SUBJECT: ISSUANCE OF AMENDMENT - DAVIS-BESSE NUCLEAR POWER STATION,
 UNIT 1 (TAC NO. MA5477)

This amendment revises the Technical Specifications (TSs) to expand the present spent fuel storage capability by 289 storage locations by allowing the use of spent fuel racks in the cask pit area adjacent to the spent fuel pool. The changes include TS 3/4.9.7, "Refueling Operations - Crane Travel - Fuel Handling Building," and associated Bases; TS 3/4.9.11, "Refueling Operations - Storage Pool Water Level"; TS 3/4.9.12, "Refueling Operations - Storage Pool Ventilation"; TS 3/4.9.13, "Refueling Operations - Spent Fuel Pool Fuel Assembly Storage;" and associated Bases; TS 5.6, "Design Features - Fuel Storage"; and related changes to the TS Index.

DAVIS-BESSE NUCLEAR POWER STATION, UNIT 1

RELATED TO AMENDMENT NO. 237 TO FACILITY OPERATING LICENSE NO. NPF-3

Figure 3.9-1
 Burnup vs. Enrichment Curves For
 Davis-Besse Spent Fuel Pool Storage Racks

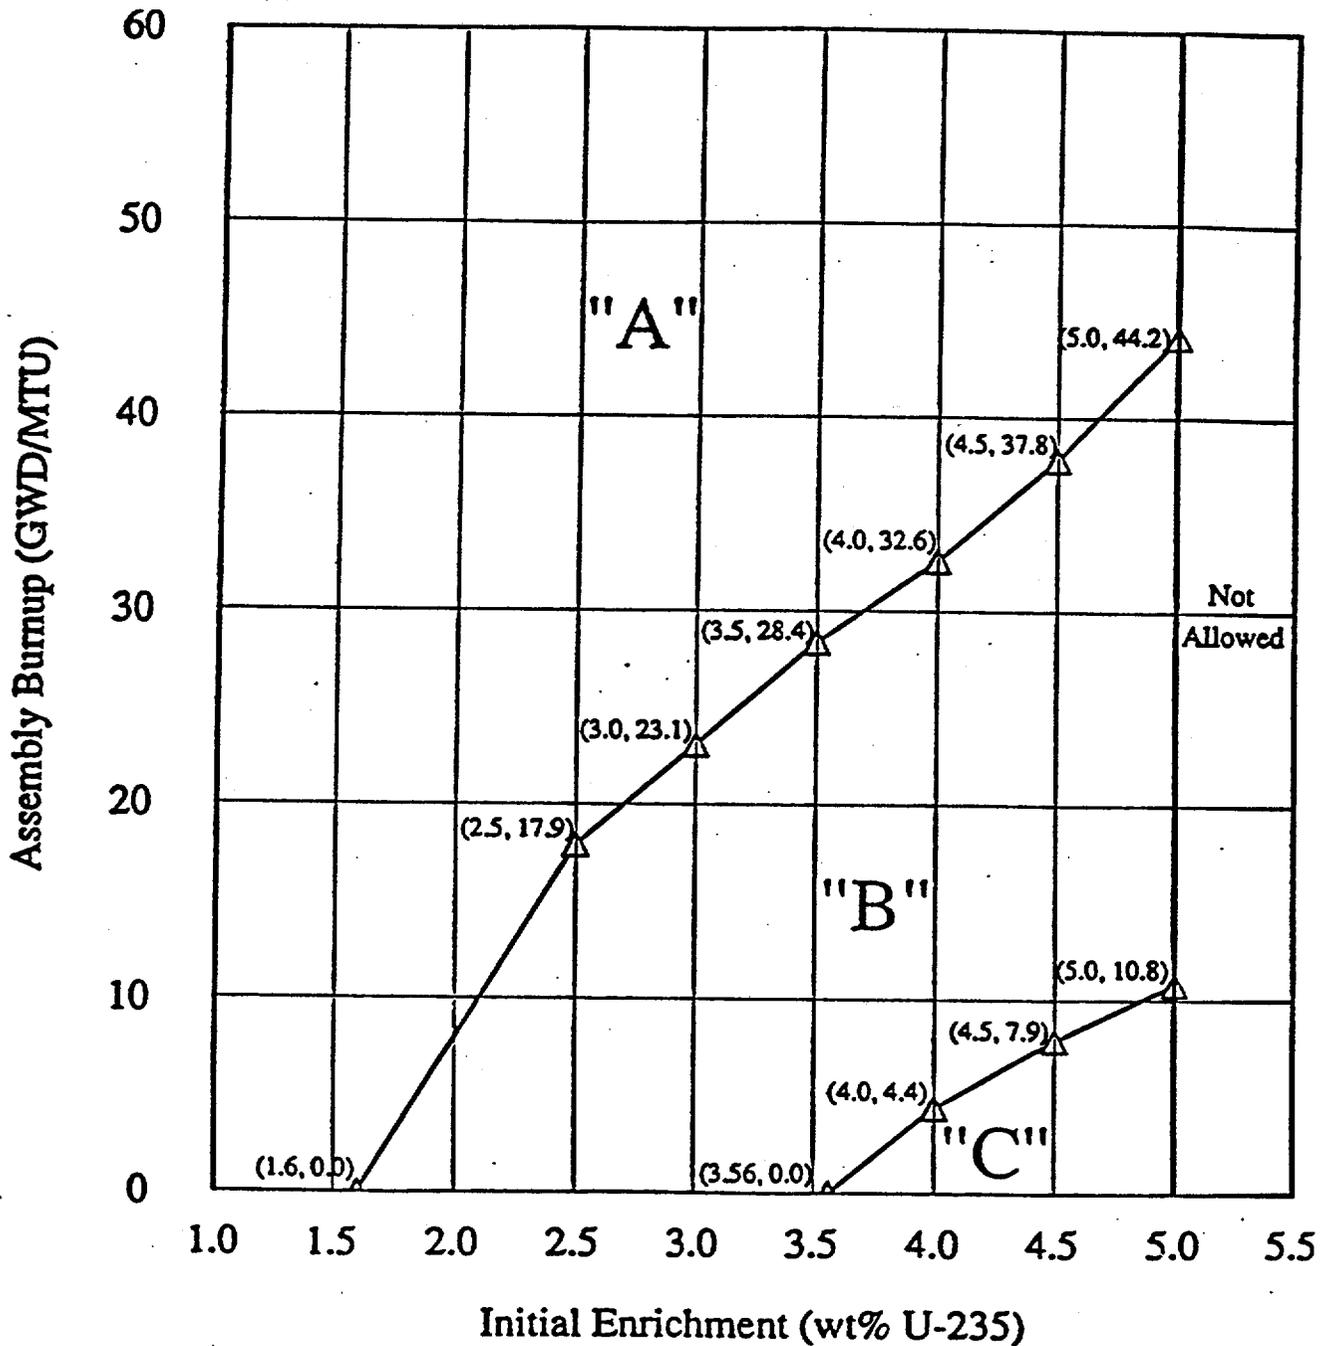
- a. Fuel assemblies stored in the spent fuel pool shall be placed in the spent fuel storage racks in accordance with the criteria shown in Figure 3.9-1.
- b. Fuel assemblies stored in the cask pit shall be placed in the spent fuel storage racks in accordance with the criteria shown in Figure 3.9-2.

Category "A": May be placed in any rack location

Category "B": Must not be placed directly adjacent to Category "C" assemblies

Category "C": May only be placed directly adjacent to Category "A" assemblies or non-fuel locations

Figure 3.9-2
 Burnup vs. Enrichment Curve For
 Davis-Besse Cask Pit Storage Racks

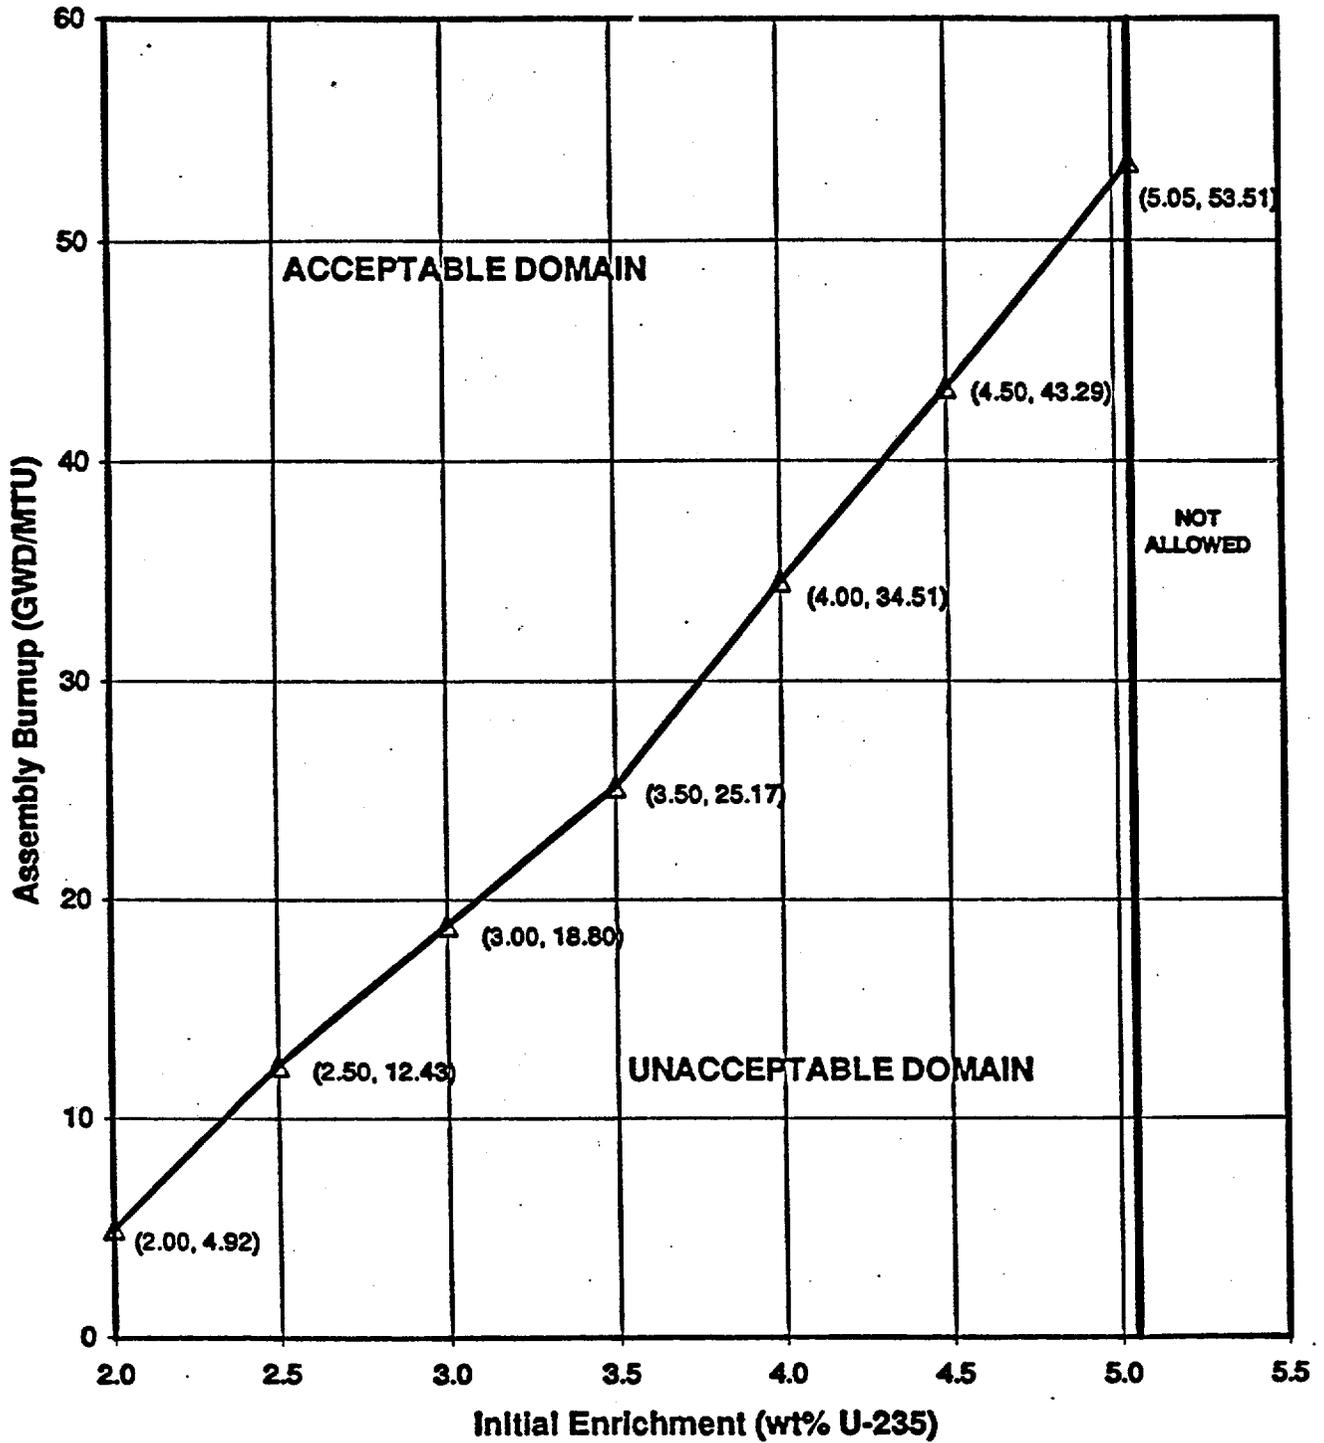
- (4) TS 3/4.9.13, "Refueling Operations - Spent Fuel Pool Fuel Assembly Storage," and related Bases would be revised to reflect the conditions required for fuel assembly storage in the cask pit area. The associated Figure 3.9-2, which shows the minimum required fuel assembly burnup as a function of initial enrichment for allowed storage in the cask pit racks, would be added.

Note: Fuel assemblies with initial enrichments less than 2.0 wt% ²³⁵U will conservatively be required to meet the burnup requirements of 2.0 wt% ²³⁵U assemblies.

- (1) For criticality consideration, the SFA must meet a minimum burnup restriction which is a function of initial enrichment as specified in the proposed TS Figure 3.9-2, "Burnup vs. Enrichment Curve for Davis-Besse Cask Pit Storage Racks," before the SFA will be allowed to be stored in the cask pit storage racks.
- (2) For thermal-hydraulic consideration, the SFA must not exceed a maximum heat generation rate restriction of 873 watts. A SFA will not be allowed to be stored in the cask pit storage racks if this maximum heat generation rate is exceeded.
- (3) For radiological consideration, the SFA must meet a restriction of 3 years minimum decay time since last irradiation. A SFA will not be allowed to be stored in the cask pit storage racks if this irradiation restriction is not met.

The final maximum calculated reactivity resulted in a k_{eff} of 0.9452 for 5.05 w/o U-235 fuel at a burnup of 53,510 megawatt days per metric ton uranium (MWD/MTU), when combined with all known uncertainties. This value meets the staff's criterion of k_{eff} no greater than 0.95 including all uncertainties at the 95/95 probability/confidence level. Therefore, the proposed storage of fuel enriched to 5.05 w/o U-235 in the racks installed in the cask pit is acceptable if it meets the burnup versus initial enrichment curve given in TS Figure 3.9-2.
